RESPONSE TO REQUEST FOR ADDITIONAL INFORMATION

APR1400 Design Certification

Docket No. 52-046

RAI No.: 374-8481
SRP Section: 18 – Human Factors Engineering
Application Section:
Date of RAI Issue: 01/22/2016

1.9 Channel Identification

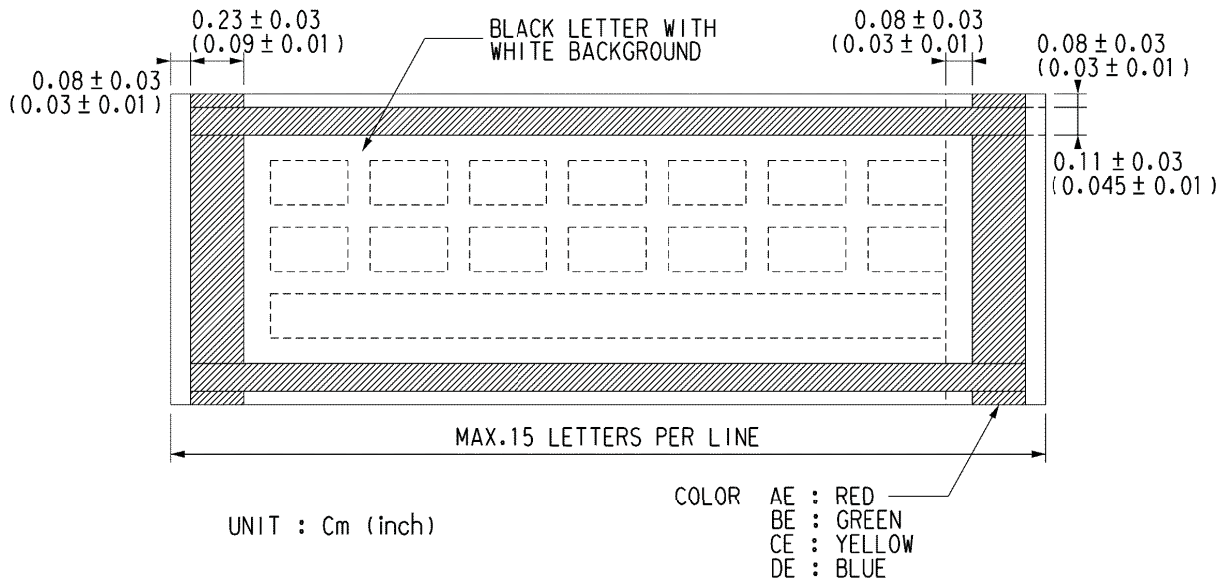
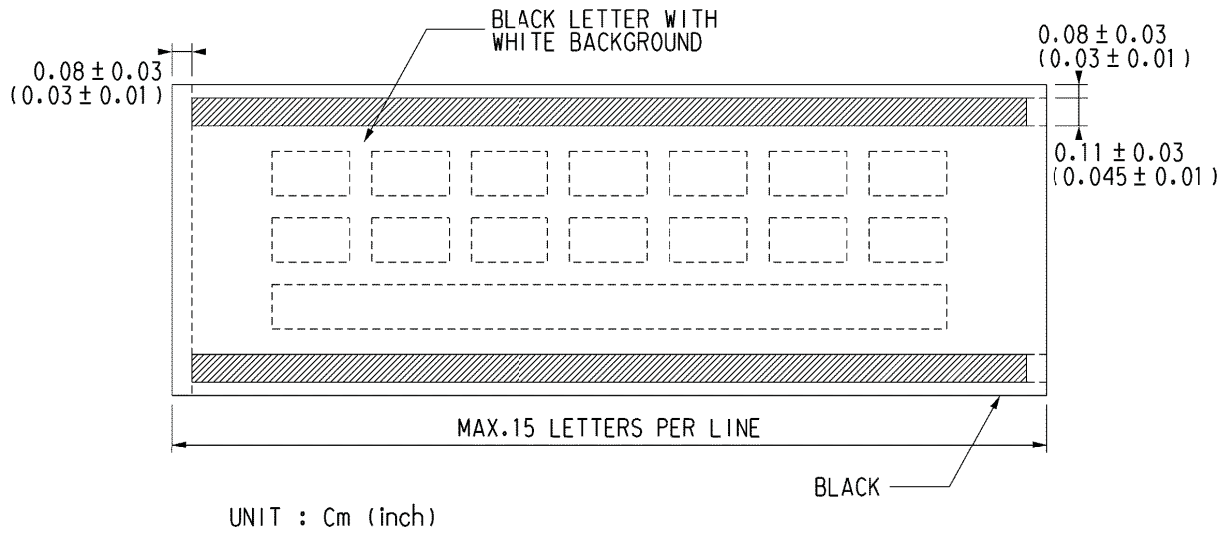
The last sentence in the Style Guide, Appendix D, Section 1.9, “Channel Identification,” appears to the staff to be missing because it indicates that some information is to be provided.

Please provide any missing information.

The color-coded nameplates for the safety console channels will be added to Section 1.9 of the Style Guide, as indicated in the attachment associated with this response.

Regarding identification of redundant Class 1E components, the following method of identifying separation group channelized controls and indicators on the safety console should be applied. This is in accordance with USNRC Reg. Guide 1.75 and in keeping with KEPCO's color-coding for related plant equipment. Each channel A, B, C, or D device on the safety console should be identified by the following color-coded nameplates.
